**Optimization Review**  
**Groveland Wells Numbers 1 and 2 Superfund Site**  
**Town of Groveland, Essex County, Massachusetts**

Report of the Optimization Review  
Site Visit Conducted at the Groveland Wells Numbers 1 and 2 Superfund Site on  
February 29, 2012

FINAL REPORT  
January 7, 2013

**Figure 6-1. Flow Chart Illustrating Suggested Decision Framework**

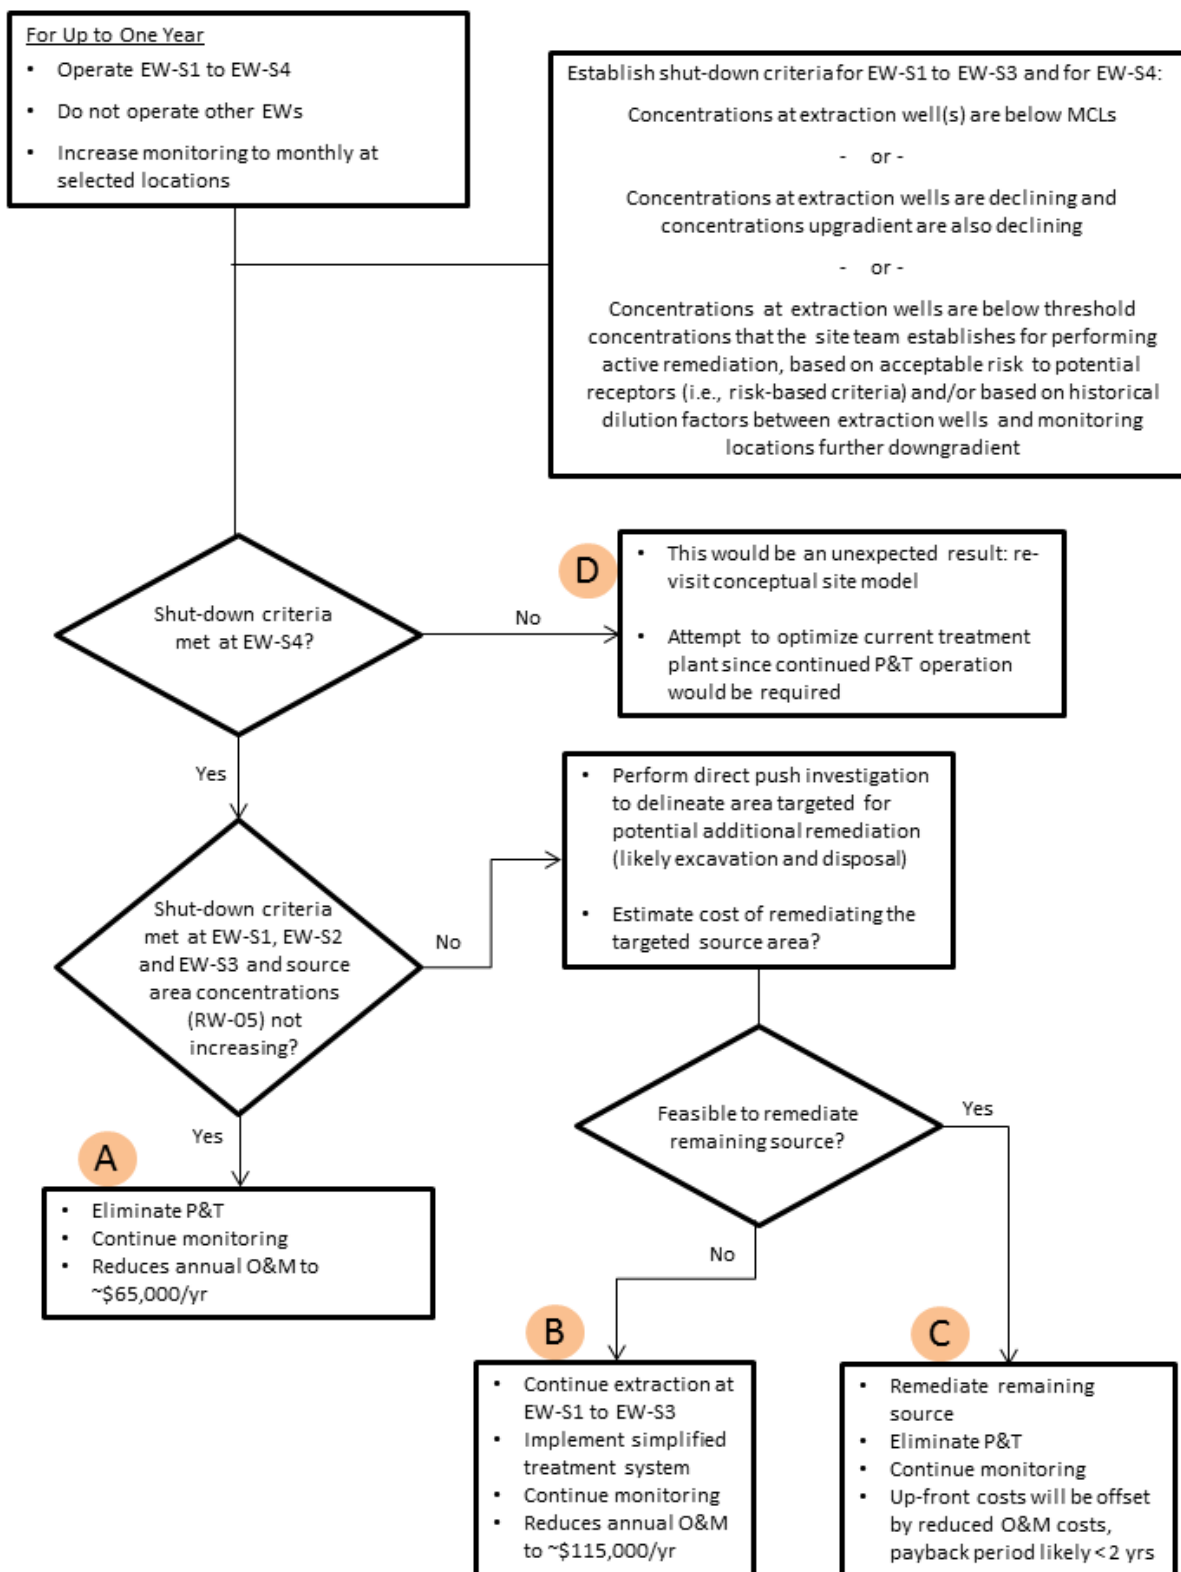
- *Outcome “A” on Figure 6-1.* A likely potential outcome is that P&T operations at this site will be terminated within 1 year (and perhaps much less than 1 year). If that occurs, the current cost of \$345,600 per year would likely be reduced to approximately \$65,000 per year (assuming \$25,000 per year for project management and \$40,000 per year groundwater monitoring). Thus, cost would be reduced by approximately \$280,000 per year for this scenario versus the current P&T system.

- *Outcome “B” on Figure 6-1.* Another potential outcome is that P&T extraction can be limited to source area wells EW-S1 through EW-S3 within 1 year, and the associated flow rate would allow for a simpler treatment approach. The current cost of \$345,600 per year would likely be reduced to approximately \$115,000 per year (assuming \$65,000 per year for the scenario with no P&T described above, plus an additional \$50,000 per year associated with management and operation of a smaller P&T system as detailed in Section 6.4.2). Thus, cost would be reduced by approximately \$230,000 per year for this scenario versus the current P&T system. It is expected that treatment plant modifications for this scenario would require up-front costs of approximately \$50,000, with payback achieved in much less than 1 year.

- Outcome “C” on Figure 6-1. Another potential outcome is that additional source area remediation (likely to consist of excavation and disposal) may be required in a targeted area to enable the complete shutdown of P&T operations. Based on the size of the targeted area, the up-front costs might range from less than \$100,000 to \$500,000 or more, as discussed in Section 6.4.2. These up-front costs would be offset by annual savings of approximately \$280,000 per year that would result from complete termination of P&T operations (as discussed in Outcome “A” above). Thus, the payback period might range from less than 1 year to as much as several years for this scenario.

- Outcome “D” on Figure 6-1. An unexpected outcome would be that downgradient extraction well EW-S4 needs to continue operating because the remaining source area is sufficiently strong and the capture provided by EW-S1 through EW-S3 is not sufficient. If this outcome occurs after the first year, it would then be appropriate to re-visit the CSM, and to optimize the current GWTF since continued P&T operation would be required.

The recommendations described below are inter-related, and an overall decision framework in the form of a flowchart is illustrated on Figure 6-1 to illustrate those interrelationships. The flowchart begins with a limited period of P&T operation that includes operation of extraction wells EW-S1 through EW-S3 plus EW-4 (see Section 6.1.1), and potential outcomes are identified as “A” through “D” on Figure 6-1. An alternative approach that does not include operation of extraction wells EW-S1 through EW-S3, and a discussion of the advantages and disadvantages of that alternative approach, is presented in Section 6.1.2.

A potential approach for addressing these shutdown criteria is indicated on Figure 6-1. However, determining the shutdown criteria for the extraction wells is not solely a technical decision, thus the optimization review team cannot provide more specific recommendations or opinions. If there is concern or uncertainty about selecting shutdown criteria, the EPA and MassDEP may decide to devise a contingency plan that allows extraction well operation to resume after shutdown if concentrations at pre-determined monitoring points increase above a pre-determined action level. The optimization review team believes that the primary effort involved in implementing this recommendation involves meetings between the EPA and MassDEP. Limited contractor support for these meetings might cost up to \$10,000.
